Well Name: CORRAL DRAW 9 FED	Well Location: T25S / R29E / SEC 9 / NENW / 32.150116 / -103.9927292	County or Parish/State: EDDY / NM
Well Number: 1	Type of Well: CONVENTIONAL GAS WELL	Allottee or Tribe Name:
Lease Number: NMNM136870	Unit or CA Name:	Unit or CA Number:
US Well Number: 3001530201	Operator: EOG RESOURCES INCORPORATED

Sundry ID: 2881093

Type of Action: Plug and Abandonment

**Permanent Abandonment of Federal Wells
Conditions of Approval**

Proposed Wellbore Diagram:

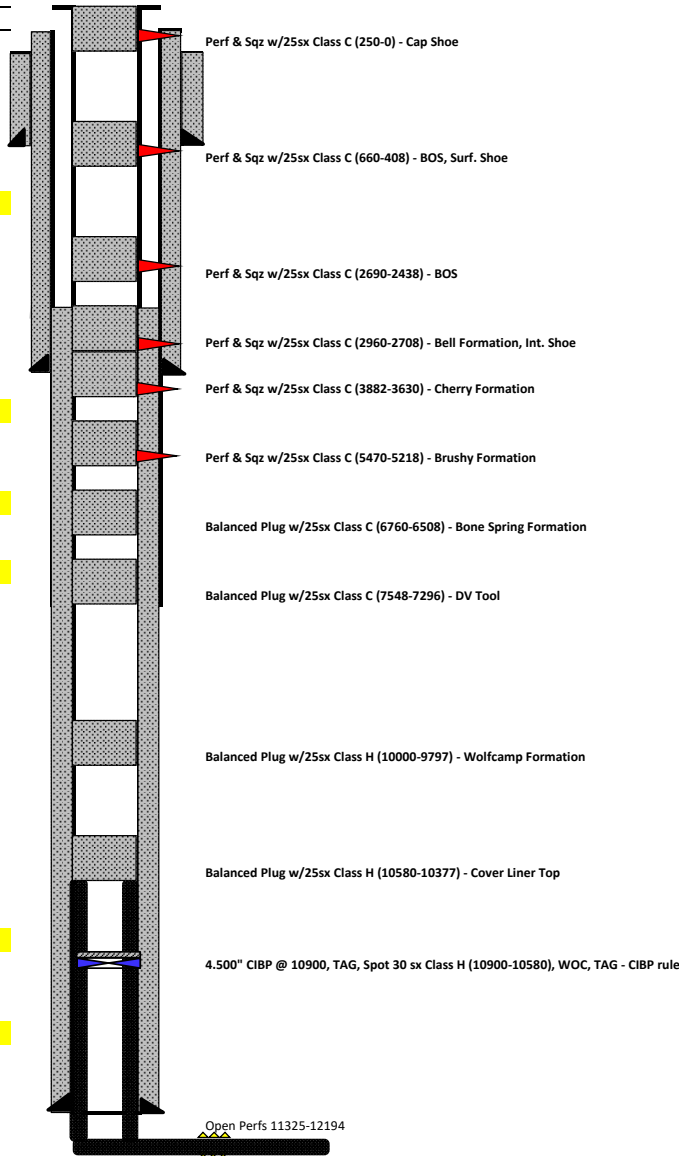
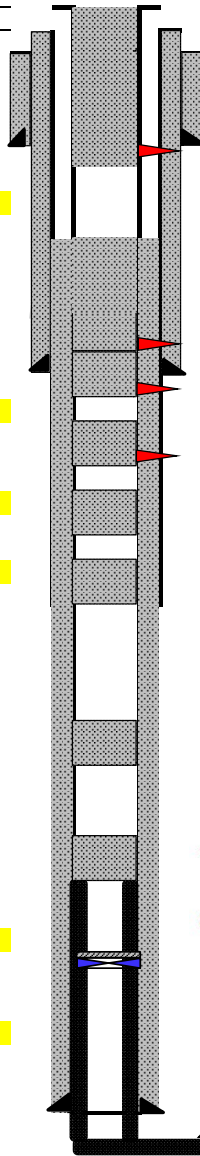
Medium Karst 350'

Perf & circulate w/194sx Class C (669-0) Verify at surface- Cap Shoe

Perf & Sqz w/151sx Class C (2960-2438) (In 85 sxs/Out 66 sxs) WOC and Tag - Bell Formation, Int. Shoe

Perf & Sqz w/39sx Class C (3882-3743) WOC and Tag (In 23sxs/Out 16 sxs)- Cherry Formation

Perf & Sqz w/25sx Class C (5470-5218) - Brushy Formation

Balanced Plug w/41sx Class C (6760-6508) WOC and Tag- Bone Spring Formation

Balanced Plug w/41sx Class C (7548-7296) WOC and Tag- DV Tool

Balanced Plug w/57sx Class H (10000-9722) WOC and Tag- Wolfcamp Formation

*Run CBL from CIBP to surface.

Submit results to BLM.

4.500" CIBP @ 10900, TAG, Spot 62 sx Class H (10900-10352), WOC, TAG - CIBP rule

7. RIH, top CIBP w/ 62 sx Class H on CIBP, 10900 to 10352. CIBP Rule. WOC. TAG.
8. Pick up, set balanced plug w/ 25 sx Class H from 10580 to 10377 for Liner Top.

9. Pick up, set balanced plug w/ 57 sx Class H from 10000 to 9722 for Wolfcamp Formation.
10. Pick up, set balanced plug w/ 41 sx Class C from 7548 to 7296 for DV Tool. WOC and tag.

11. Pick up, set balanced plug w/ 41 sx Class C from 6760 to 6508 for Bone Spring formation. WOC and Tag.
12. Pick up, Perf & Sqz w/ 25 sx Class C from 5470 to 5218 for Brushy Formation. WOC, TAG.

13. Pick up, Perf & Sqz w/ 39 sx Class C from 3382 to 3743 for Cherry Formation. WOC, TAG. (In 23 sxs/Out 16 sxs)
14. Pick up, Perf & Sqz w/ 151 sx Class C from 2960 to 2438 for Bell Formation, Int. Shoe, WOC TAG. (In 85 sxs/Out 66 sxs)

15. Pick up, Perf & circulate w/ 194 sx Class C from 669 to 0 for Cap Plug. Verify at surface.
16. Cut off WH 3' below surface, verify cement to surface, and weld on below ground P&A marker.
